PENTHOUSE ROOF FRAMING PLANS - AREAS A AND H
NEW COMBINATION HARFORD ACADEMY & ELEMENTARY SCHOOL
1608 EVA MAR BOULEVARD, BELAIR, MARYLAND

DATE	DESCRIPTION
01/23/26	ADDENDUM #2
01/30/26	ADDENDUM #3

PARTIAL PLANS - AREA H (ALTERNATE)
NEW COMBINATION HARFORD ACADEMY & ELEMENTARY SCHOOL
1608 EVA MAR BOULEVARD, BELAIR, MARYLAND

BIDDER'S QUESTIONS - Attachment C

ALTERNATE - PARTIAL ROOF FRAMING PLAN - AREA H

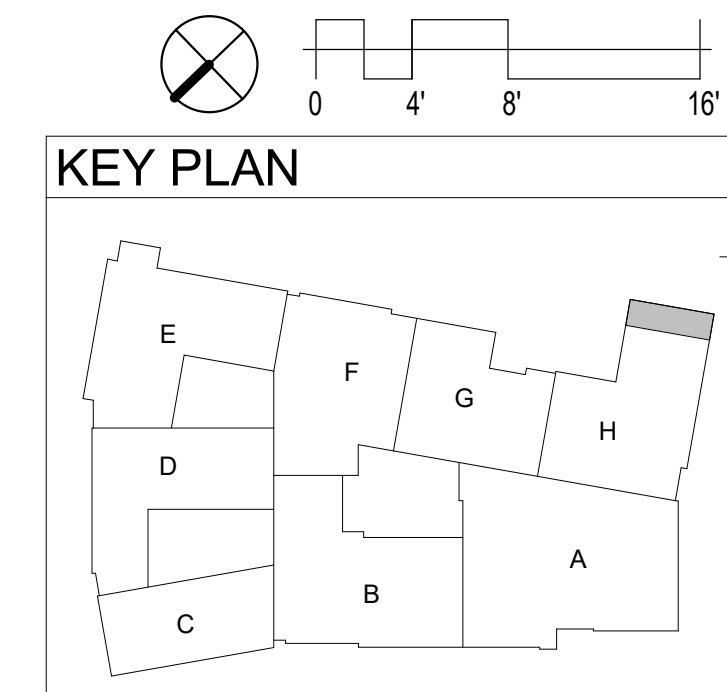
S105 Alternate - Partial Roof Framing Plan - Area H, note #4 states to see the Architectural drawings for the locations of the PV panels on the roof, but we can't find them on the Arch. drawings.

PV Panels are not being provided as part of the project. Note referencing PV panels will be revised.
